Access Compliance Report

Public Rights-of-Way

(Curb Ramps)

Intersection ID: 6674	Main Street: MCLEAN_RD	Cross Street: AVEBURY_DR	Location: SE
ADA ID: 98878EEA2FDE	Ramp Type: BlendTrans1	Initial Pass/Fail: Fail	Overall Compliance: No
Severity Score: 10			
Codes/Mitigation Info/Possible Solution		Field Measurements/Component Compliance

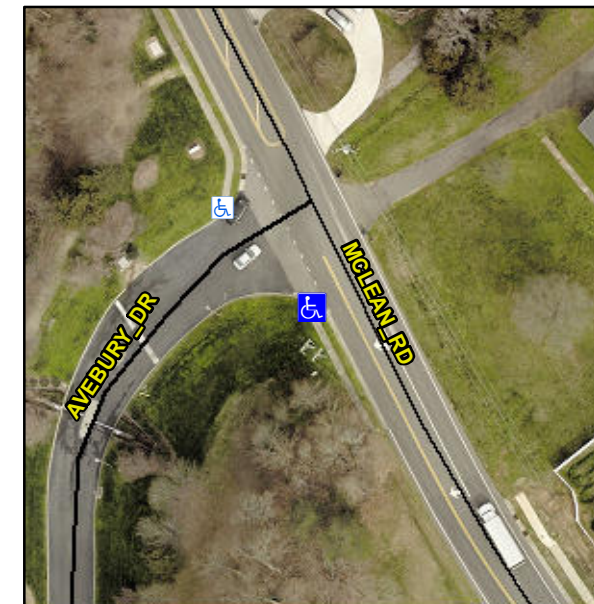
CURB LIP 2.0

Not Found, R304.5.1

Compliance	Description	Data	Compliance	Description	Data
N/A	Ramp Length (in)	100.0	Yes	BlendTrans Slope (%)	2.5
No	Ramp Width (in)	47.5	Yes	BlendTrans XSlope (%)	2.4
N/A	Flare Type LT	N/A	N/A	Flare Type RT	N/A
N/A	Flare Slope LT (%)	N/A	N/A	Flare Slope RT (%)	N/A
N/A	Flare Traversable LT?	N/A	N/A	Flare Traversable RT?	N/A
N/A	Landing Length (in)	N/A	N/A	DWS Provided?	N/A
N/A	Landing Width (in)	N/A	N/A	DWS Contrast?	N/A
N/A	Landing Slope (%)	N/A	N/A	DWS Length (in)	N/A
N/A	Landing X Slope (%)	N/A	N/A	DWS Full Width?	N/A
N/A	Landing Curb? (Y/N)	N/A	N/A	DWS Offset (in)	N/A
N/A	Shared Landing?	N/A			
N/A	Gutter Ponding?	N/A	N/A	Gutter Slope (%)	N/A
N/A	Gutter Lip Ht (in)	N/A	N/A	Gutter X Slope (%)	N/A
N/A	Painted X Walk1?	No	N/A	Painted X Walk2?	N/A
	X Walk 1 Direction	To NW		X Walk 2 Direction	N/A
	X Walk 1 Width (in)	N/A		X Walk 2 Width (in)	N/A
	X Walk 1 Slope (%)	5.7		X Walk 2 Slope (%)	N/A
	X Walk 1 X Slope (%)	4.2		X Walk 2 X Slope (%)	N/A

N/A	Ramp inside XWalk1?	N/A	N/A	Ramp inside XWalk2?	N/A
	Road Slope (%)	4.2		Clear Space?	N/A
	Road X Slope (%)	5.7	N/A	Clear Space to XWalk (in)	N/A
N/A	Any Obstructions?	N/A	N/A	Storm Grate/Utility Hazard?	N/A
	Obstruction Type			Storm Grate/Utility Type	
		N/A			N/A
			Yes	Surface Condition? (G/P)	Good
			No	Curb Slope (%)	22.5

Remove & Replace Curb Ramp With Two New Directional Ramps or Equivalent.
